City of Dallas

City Plan Commission

CITY PLAN COMMISSION
THURSDAY, MARCH 2, 2023
AGENDA

REVIEW BY:	DRAWN BY:	DATE	FILE	NUMBER	SHEET
LIM	LIM	NOV 2022	3117	10059	C08D2

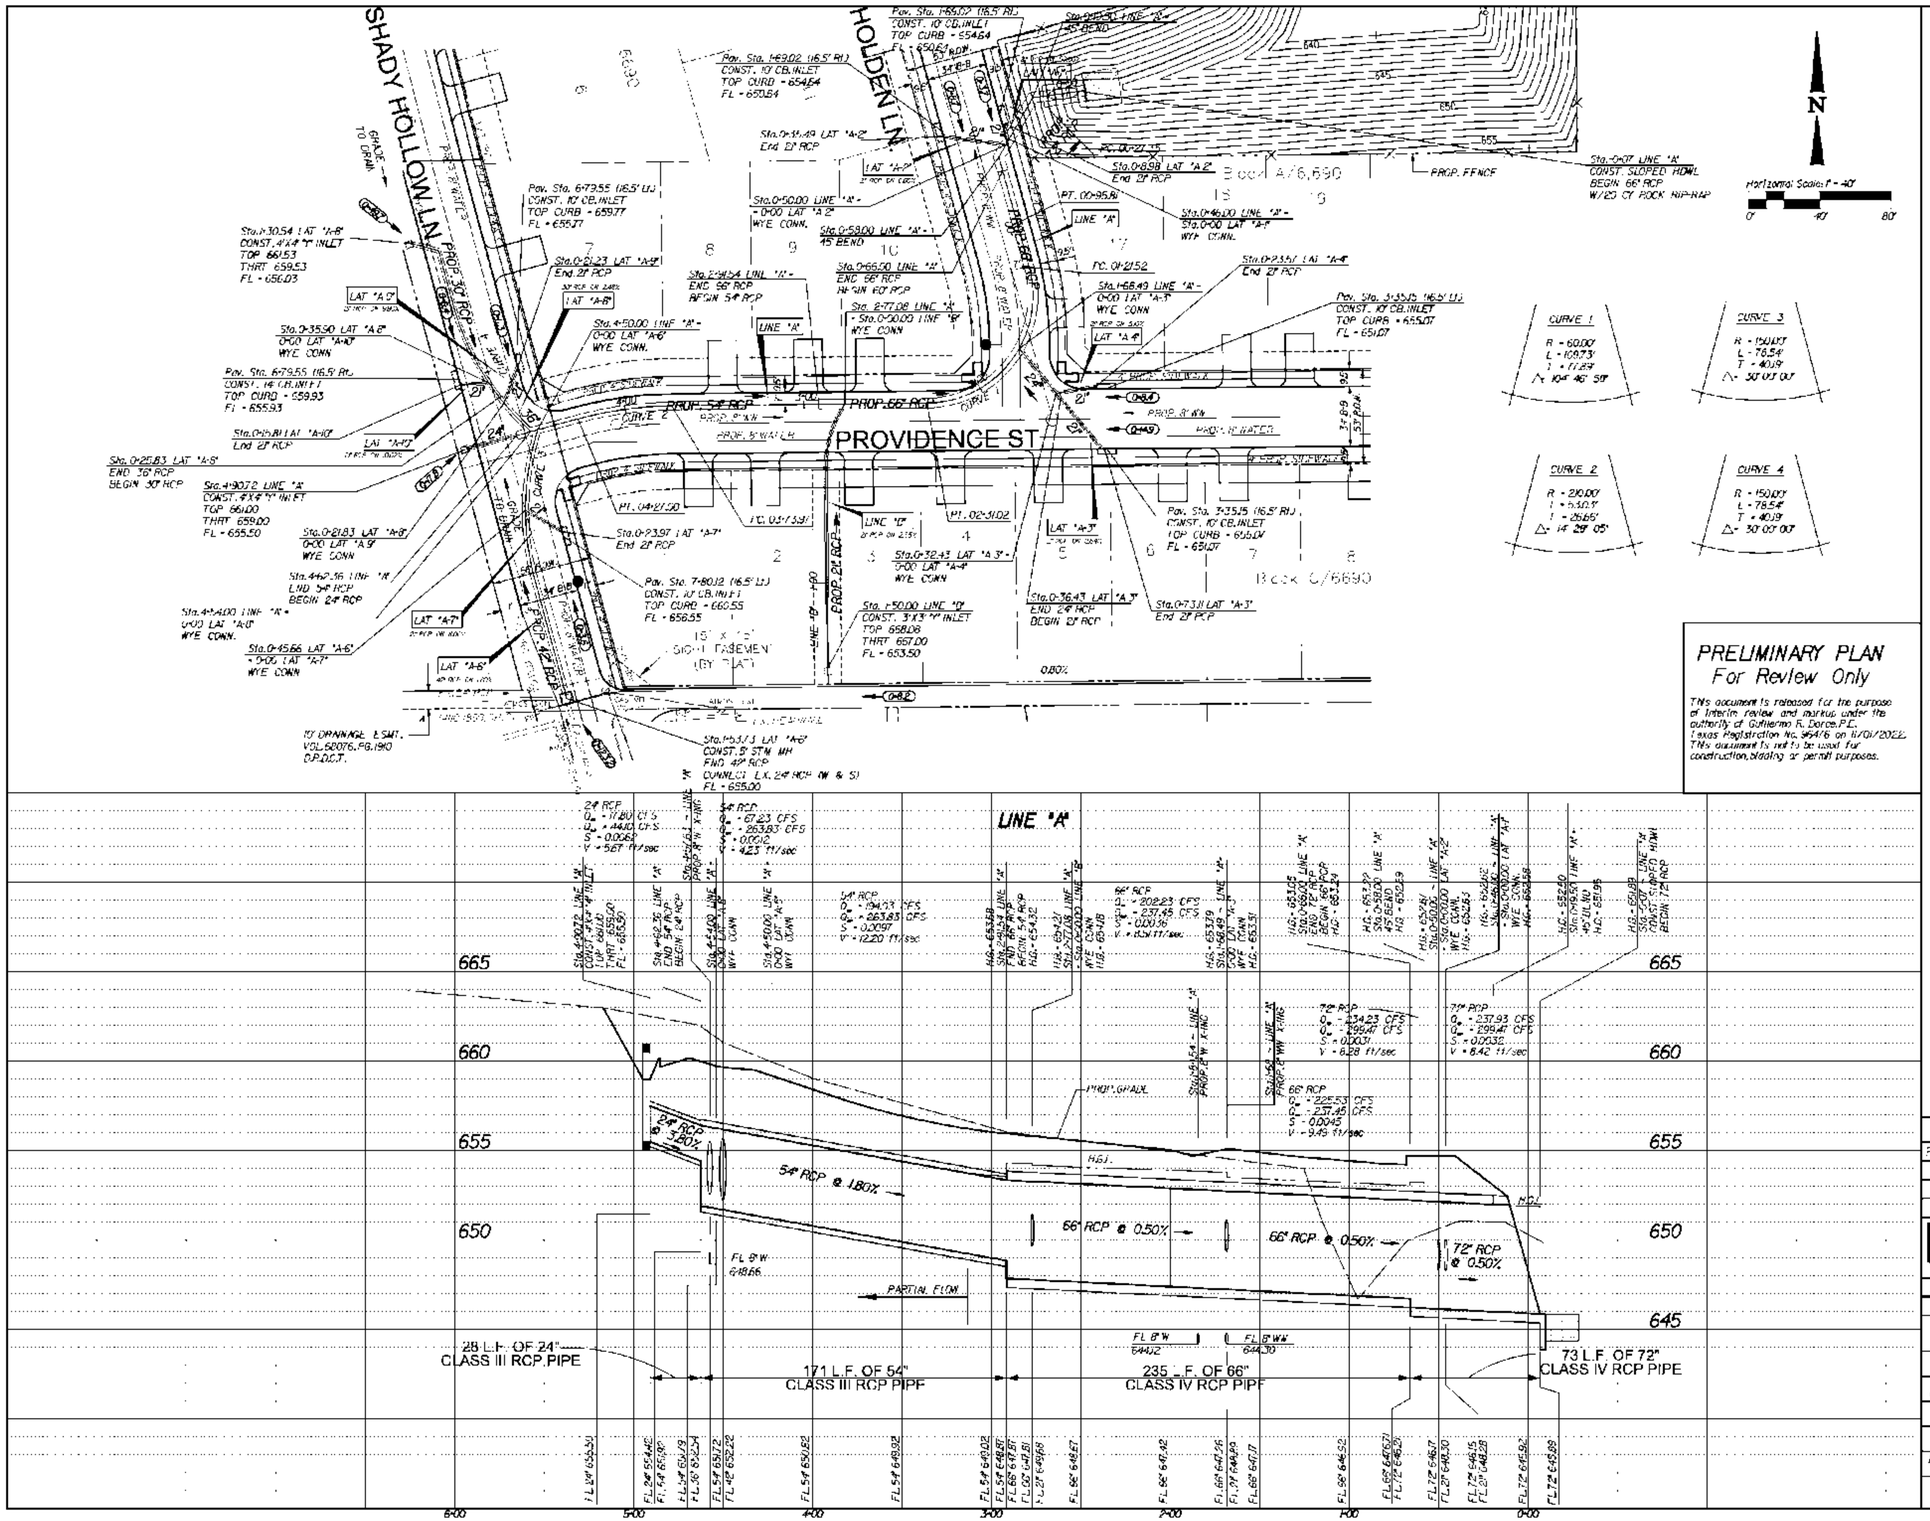
1. Sheet C08.02, Proposed Drainage Area Map does not show a revised delineation of area draining to the detention pond within area D1. Some of this area will drain directly into the detention pond and should be accounted as part of the pond design.

26. On sheet C08.02 shows rear of these lots draining to Wenatche Drive. Make sure drainage patter is consistent with the proposed grading.

26. On sheet C08.02 shows rear of these lots draining to Wenatche Drive. Make sure drainage patter is consistent with the proposed grading.
We have adjusted grading plan to match drainage pattern.

REVIEW BY:	DRAWN BY:	DATE	FILE	NUMBER	SHEET
LIM	ERB	OCT 2022	311T	10059	C09.04

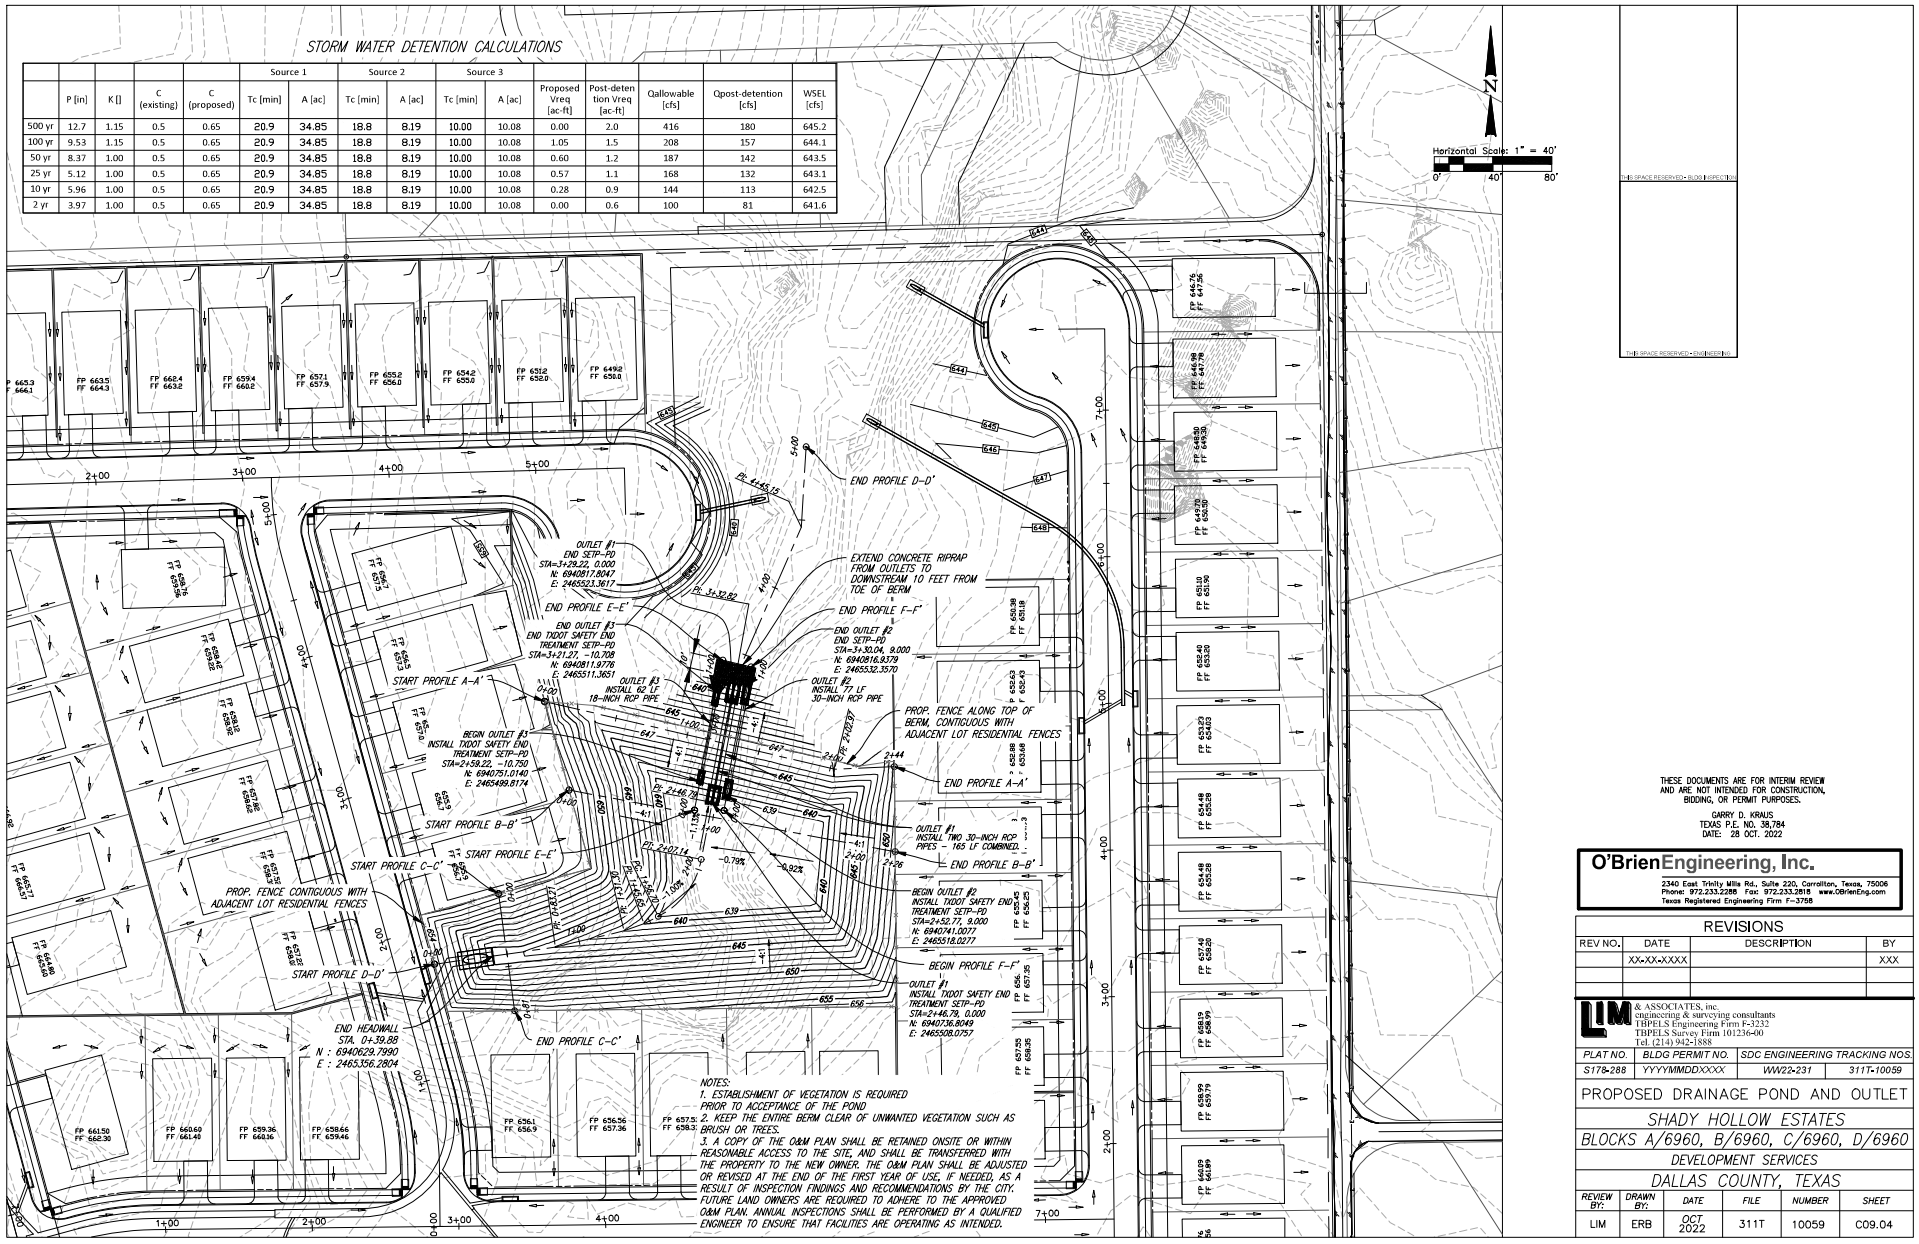
2. Related to **Comment 1**, it is unclear how the stormwater detention calculations are derived with incorrect hydrology in Sheet C09.04.
3. Sheet C09.04, Proposed Drainage Pond and Outlet, the detention pond calculations use a non-standard methodology that is not documented or justified anywhere in these plans. As part of this review, the standard methodology was used to evaluate the pond and have determined that storage is undersized by a factor of 2-3 when accounting for the hydrologic parameters presented on Sheet C08.01 and Sheet C08.02, and the previously approved existing conditions calculations of 311T-9437, S167-275 (Blue Ridge Estates). A sample of a compliant Modified Rational Method spreadsheet analysis of the 100-year storm is shown in **Figure 1**.

29. On Sta. 4+90.72 Line A, it appears there is a typo with a "4" INLET instead of "Y" INLET in both the plan and profile, please revise as needed.
30. On sheet C09.04, the detention calculations, justify the Q allowable of 353 cfs. Based on 311t-9437 plans, downstream system was designed for Q100 of approximately 220 cfs from this discharge location.

30. On sheet C09.04, the detention calculations, justify the Q allowable of 353 cfs. Based on 311t-9437 plans, downstream system was designed for Q100 of approximately 220 cfs from this discharge location.
See revised calculation on sheet C09.04.

31. Provide required detention volume calculations using the Modified Rational Method.
See revised calculation on sheet C09.04.

32. Provide elevation vs. storage volume table for the detention volume provided.
See revised calculation on sheet C09.04.
